RESPONSE TO SUBMISSIONS LETTER - TRAFFIC/VEHICLE MOVEMENTS

TTPP REF: 16222

RE: Proposed Resource Recovery Facility, 20 Hearne Street Mortdale (SSD 7421)
Response to Submissions

Figure 1: Traffic Controls at Site Access

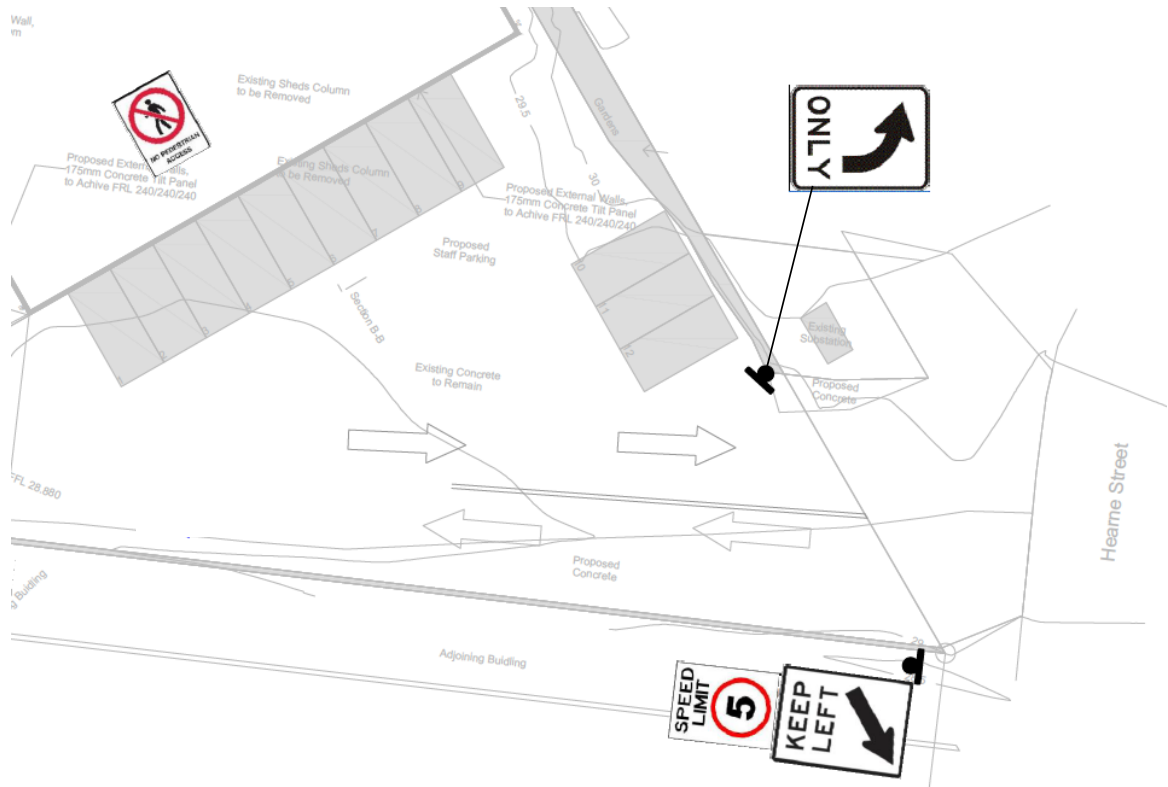
Additional information provided in TIA Letter, however the information lacks any detail regarding management of trucks at the site entry. Figure 2 depicts traffic controls which are all internal - there are no proposed controls at the entrance to avoid conflict with vehicles entering and exiting. If an exiting truck takes a wide berth, an incoming truck would not be able to enter.

Further details are required regarding management of vehicles entering and leaving the site to avoid queuing within the road reserve and traffic safety issues.

Traffic movements at the site access would be managed by implementing the following controls:

- Two-way traffic flows would be delineated by arrow stencils on the driveway. Traffic flows into and out of the site would be separated by a double barrier line (two-way). Delineation on the driveway would be provided in accordance with the design specification in RMS' Delineation Guidelines Section 4 – Longitudinal Markings and Section 10 – Pavement Arrows. Providing linemarking in line with RMS guidelines would ensure driver familiarity of information portrayed by the linemarking and to follow instructions accordingly.

- A Left Arrow Only sign is to be erected at the site access to instruct all drivers exiting the site to turn left when entering Hearne Street. As currently practiced, drivers would be informed of the approved haul routes to the site as part of their staff induction. Emphasis would be placed on the routes into the site via Hearne Street to/from the north, and that access via Barry Avenue is not permitted.

- A traffic controller would be stationed at the driveway access during site operation to supervise traffic movements on the driveway and on Hearne Street, near the site access.

The above controls at the site access are illustrated in Figure 1 while designated areas of supervision by site staff are shown in Figure 2. A traffic control plan showing measures across the entire site is provided in Attachment A.

Figure 4: Semi-Trailer Swept Path and Stacking Plan

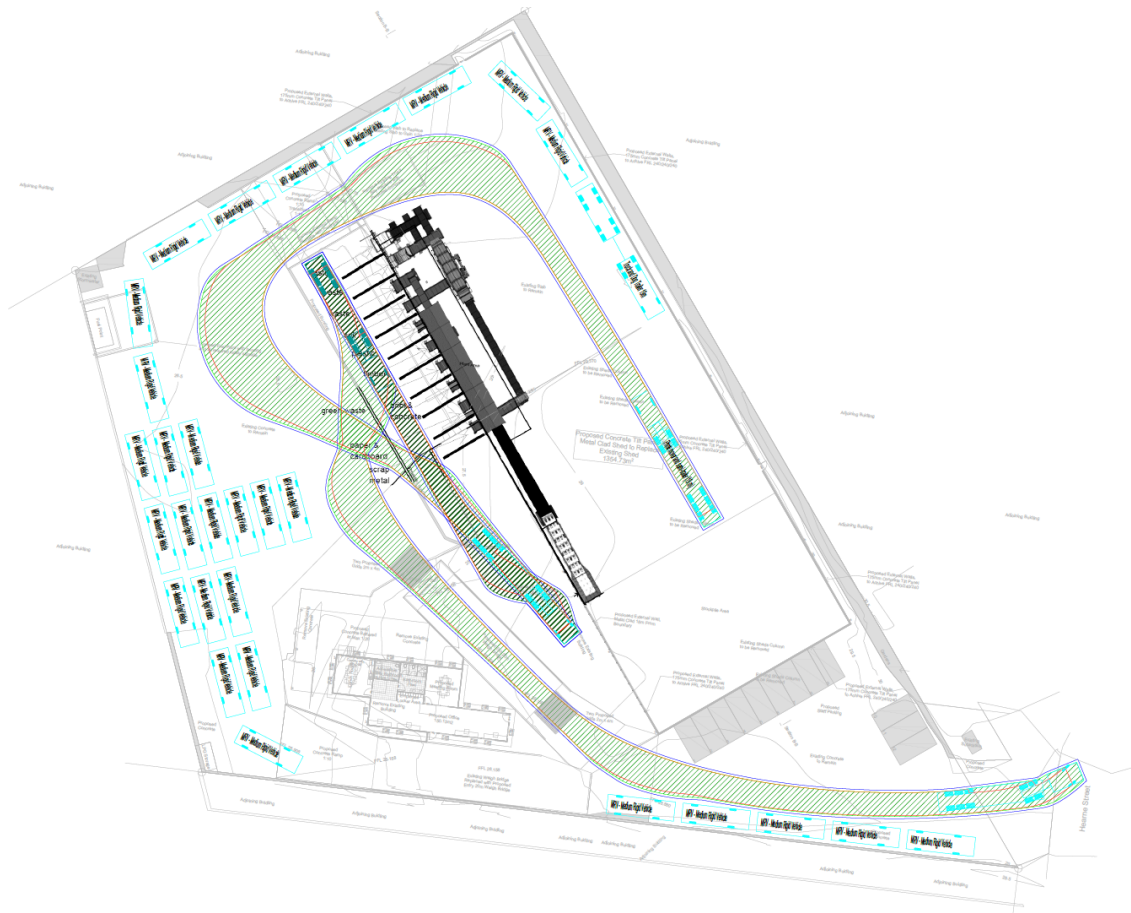
Exiting trucks have been placed in a location which contradicts the stacking plan diagrams. This requires amendment.

As shown in Figure 4 the proposed vehicle stacking arrangement would simultaneously accommodate 30 stacked vehicles and the largest waste delivery truck (ie. semi-trailer) exiting the site.

As the vehicle with the most restricted turn movement, the swept path of a semi-trailer moving from the tip floor (on the upper deck) to the waste stockpiles (lower deck) then site exit would be achieved as shown in Figure 4. This swept path is also included in Attachment B.

Figure 5: Truck-and-Dog Swept Path and Stacking Plan

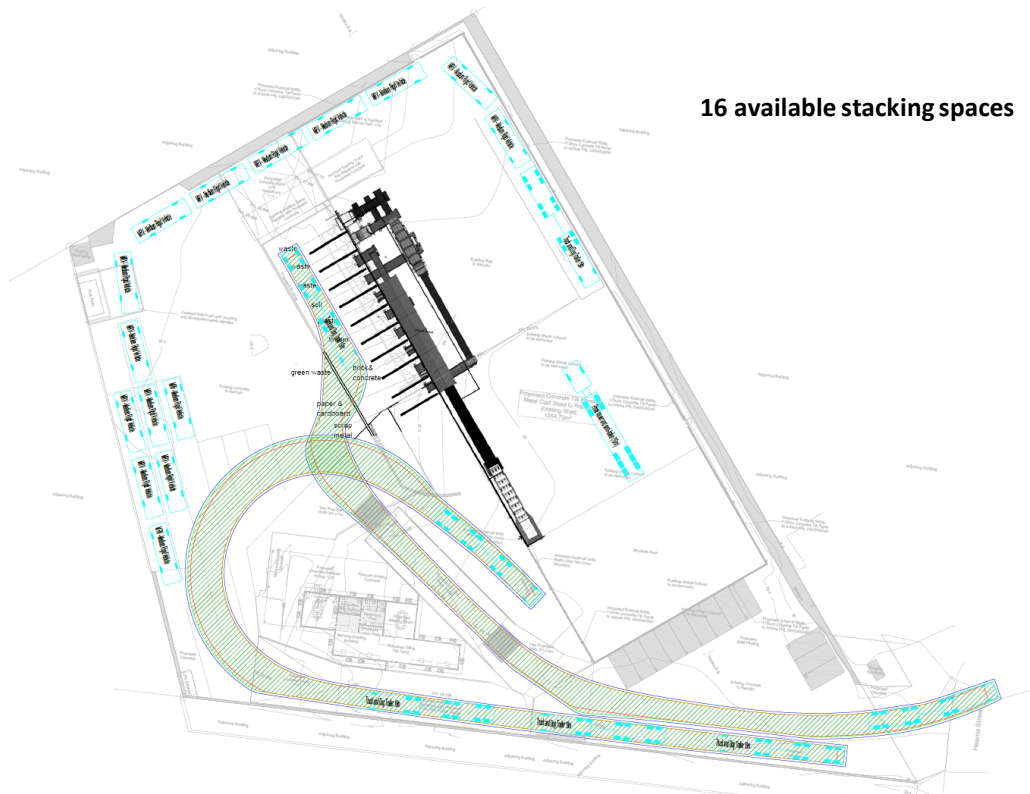
The vehicle stacking plan “Response to Submissions Letter – Traffic Vehicle Movements” Attachment C) conflicts with many of the provided swept path arrangements for 19m vehicles indicated in (“Response to Submissions Letter – Traffic Vehicle Movements,” Attachment G). The introduction of semi-trailers/truck and dog vehicles into the site has the potential to impact on the timing of queueing arrangements within the site which may increase the assumed vehicle processing turnover time of 25 minutes (as indicated on page 7). Any potential conflict between queueing and turning vehicles that leads to vehicle queueing on Hearn (or surrounding) streets is not supported.

The 68 required daily pick up movements is highly likely to result in some conflict between the large (semi-trailer/truck and dog vehicles) and the smaller drop-off MRV's as the allocated queueing spaces conflict with the required turning circles of the pick-up vehicles. This is likely to result in queuing of trucks on Hearne (and surrounding) streets. Council strongly objects to this outcome. As vehicle movements and queueing for the proposed operation are not likely to be able to be accommodated within the boundaries of the site, Council argues that the site is of an insufficient area for the use at the tonnage proposed.

In order to ensure the availability of turning space for a waste collection truck upon arrival, the Traffic Controller on the lower deck would direct waste delivery trucks to stack along the western boundary before commencing to double-stack side-by-side. The swept paths of a truck-and-dog and semi-trailer accessing the stockpiles with the number of available stacking spaces are shown in Figure 5 and Figure 6, respectively

Of both vehicles, the semi-trailer requires a greater area to adequately turn into the waste collection bay. In this scenario, up to 14 stacking spaces would still be available for use by waste delivery trucks across the upper and lower decks (queuing along the western boundary). Fourteen spaces remains in excess of the nine spaces required to accommodate the 21 trucks expected to arrive during peak operation. Therefore, there would be sufficient area onsite to accommodate waste pick-up and drop-off activities simultaneously without causing queuing onto Hearne Street.

Stacking plans showing a truck-and-dog and semi-trailer arriving for waste collection are shown in Figure 5 and Figure 6, respectively. The full plans are included in Attachment C.

Figure 7: Traffic Movements To/From Site During Peak Periods

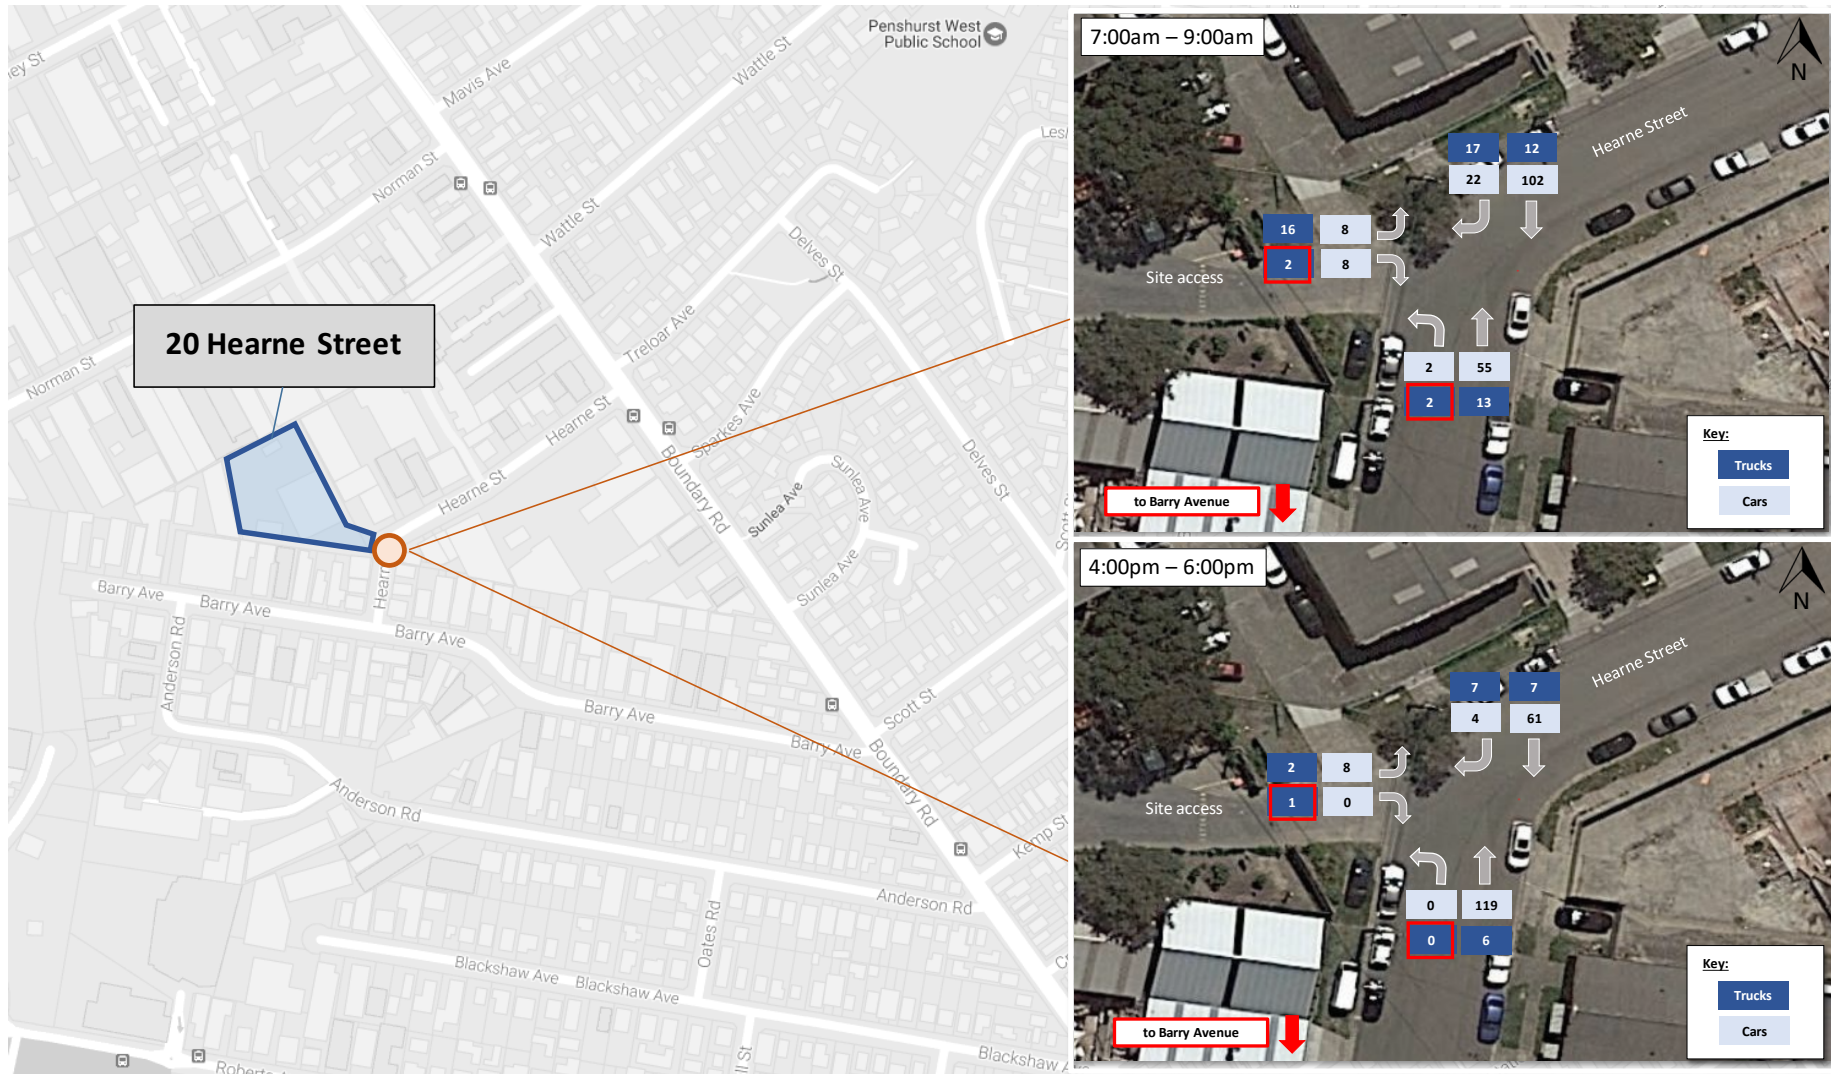
In relation to Barry Avenue, the EPA notes that predicted noise levels from the additional traffic generated by the proposal are acceptable along the simulated route. However, this route assumes that trucks do not access the facility via Barry Avenue.

One item which DPE may wish to consider is the inclusion of a condition on any approval that requires the Proponent to include, if possible and enforceable, clauses in any contracts with truck drivers requiring them not to use Barry Avenue. Alternatively, Council may be able to place weight restrictions on Barry Avenue. This would lessen noise from truck traffic for those residents on Barry Avenue.

The EPA notes that, while the Proponent has included a commitment to "encourage all vehicle access to the site via Boundary Road and Hearne Street" in their Statement of Commitments, Barry Avenue is a public road that any road registered vehicle is entitled to use.

Turning movement surveys at the site access indicate a very low number of trucks accessing the site via Barry Avenue in the surveyed morning and afternoon peaks. Across the two-hour peak period in the morning, a total of two trucks were surveyed entering and leaving the site (per direction) via the south of Hearne Street, and subsequently, via Barry Avenue. In the afternoon period, a single truck was surveyed leaving the site via the south of Hearne Street. These traffic movements are illustrated within the context of the local road network in Figure 7.

As shown above, the volume of heavy vehicles accessing the site via the south of Hearne Street (ie. Barry Avenue) is close to nil. This demonstrates that the current measures implemented by the Operator to avoid heavy vehicles accessing the site via Barry Avenue are effective. The Operator would aim to achieve all trucks travelling via the north of Hearne Street by incorporating a haul route plan into its truck driver training and induction pack.

Traffic Control Plan

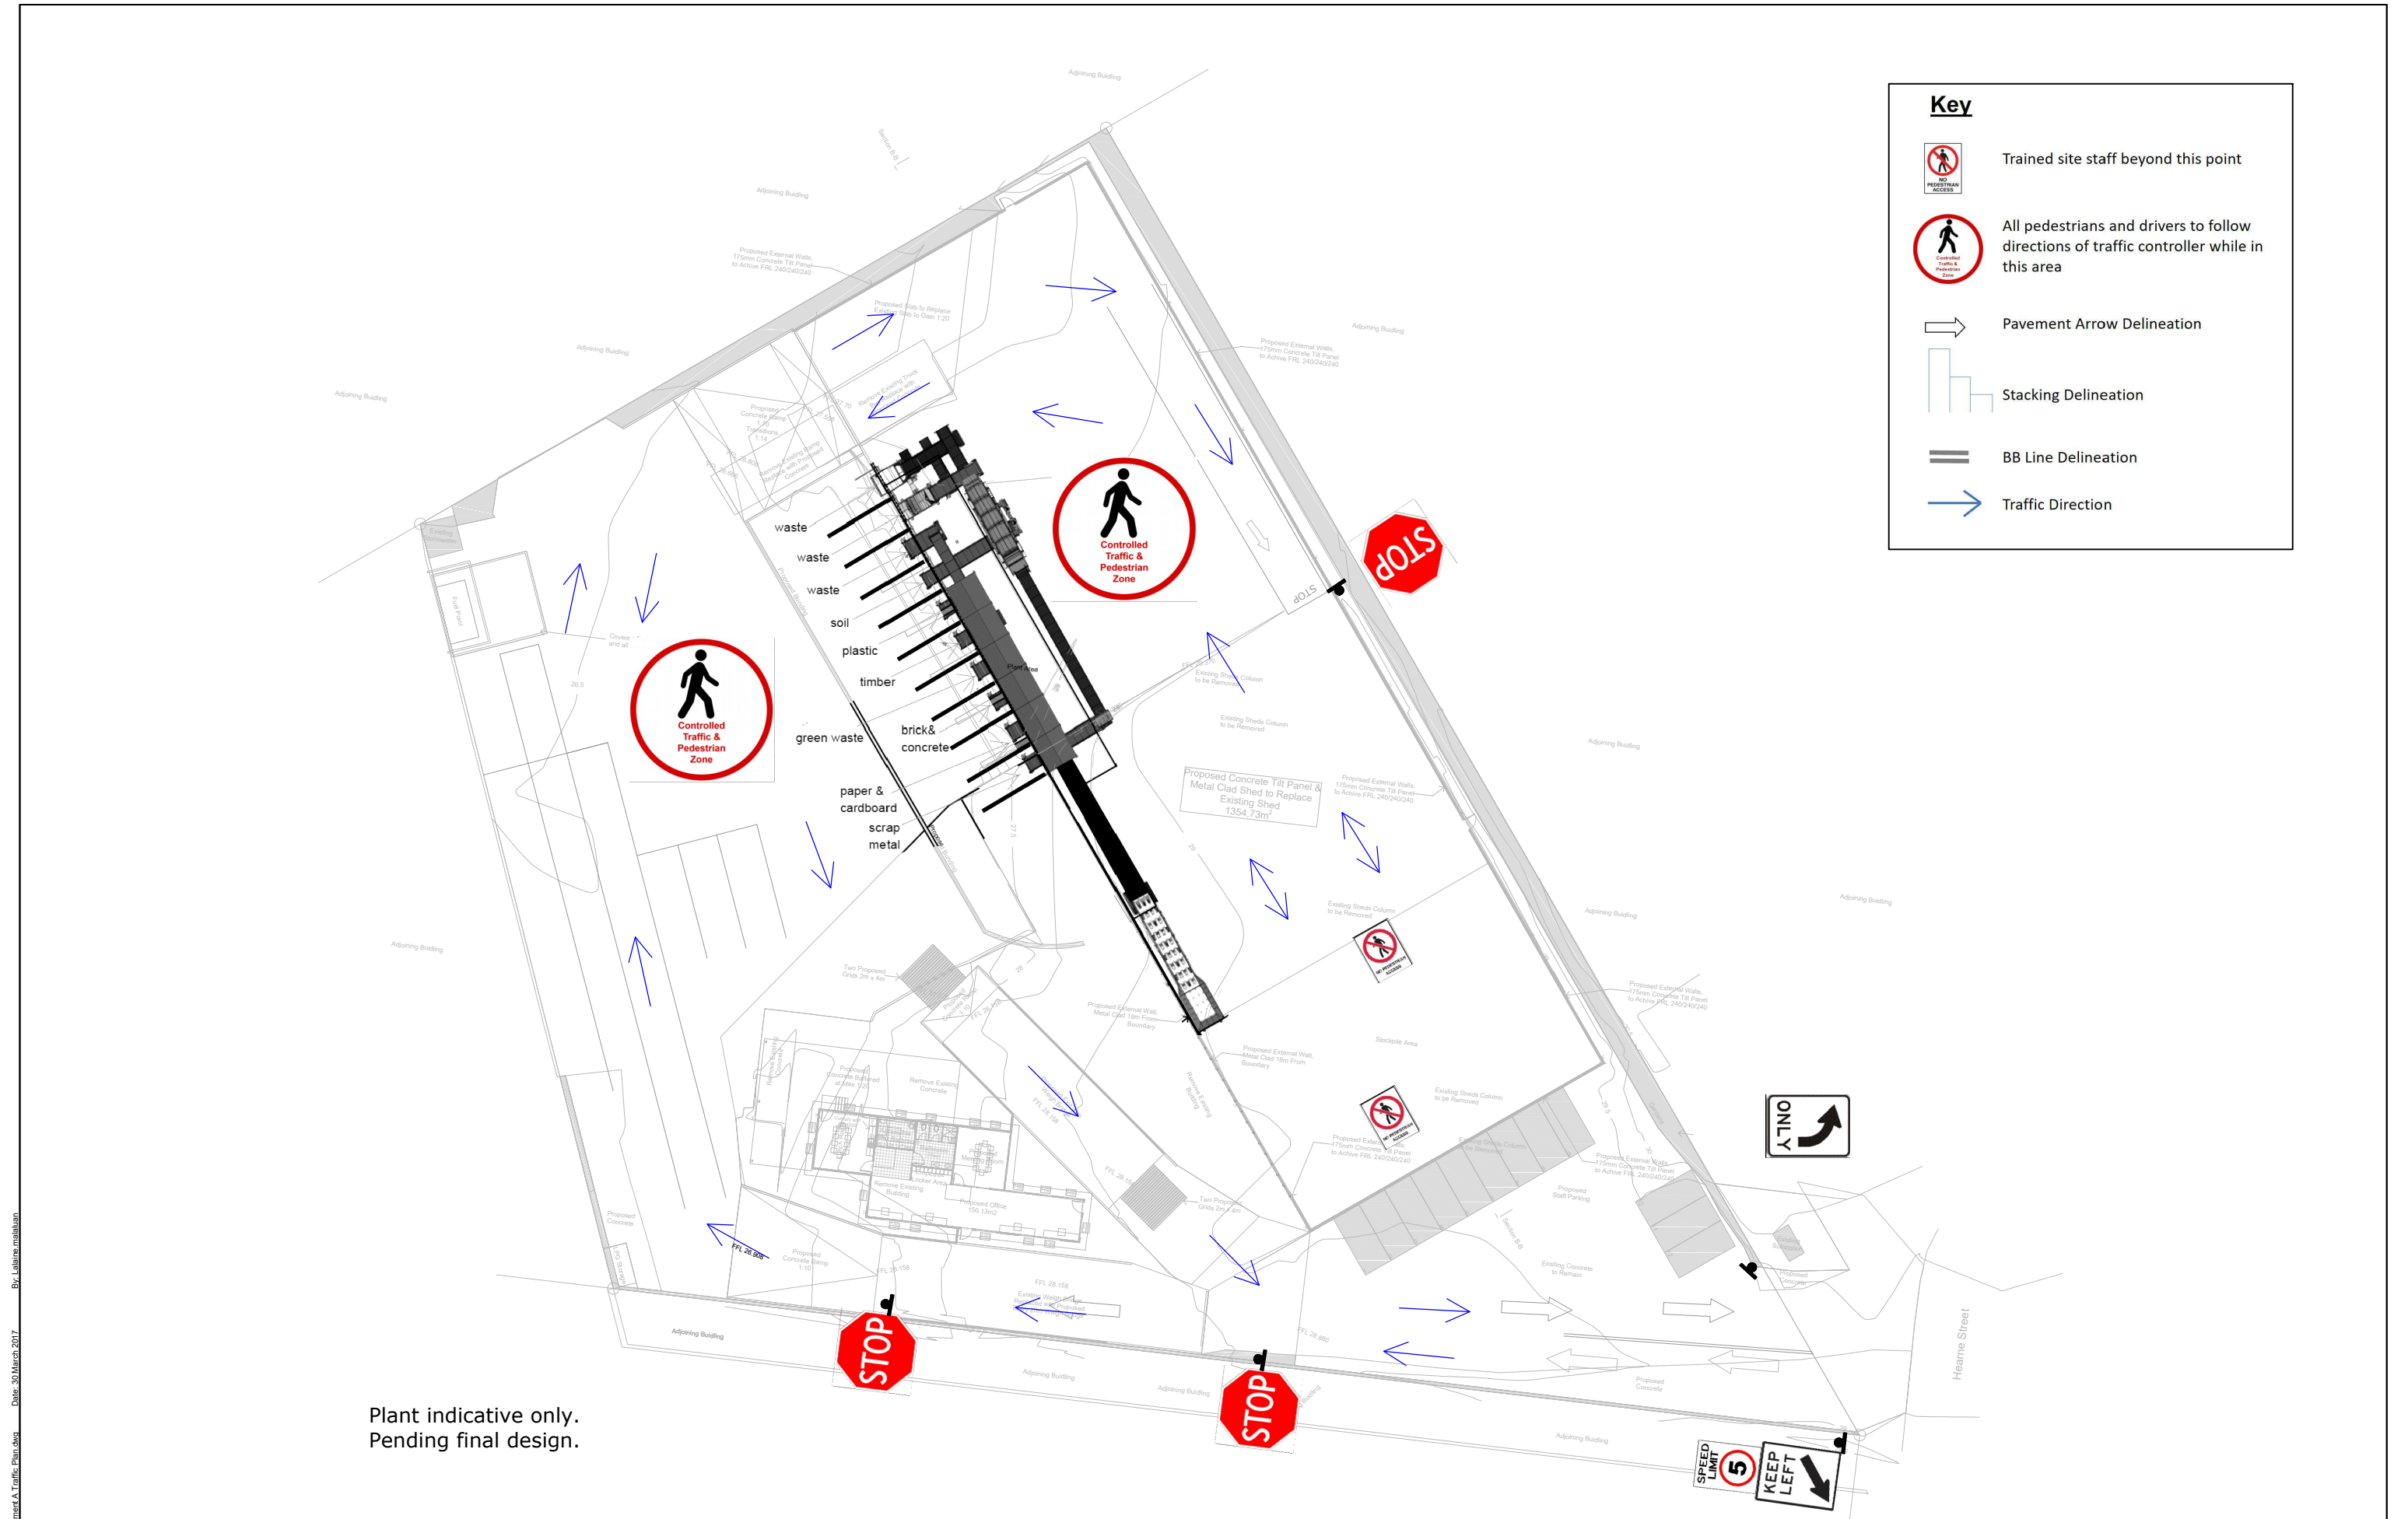
A stacking plan has been provided which only shows the stacking of heavy rigid trucks on site. There is no plan showing the stacking of semi-trailers collecting sorted materials. There is no indication of how traffic will be controlled at the access way. In particular, how will trucks be directed to the stacking locations. Further, the stacking plan contradicts the internal turning path diagrams with vehicles stacked in areas required for manoeuvring. Further clarification is required.
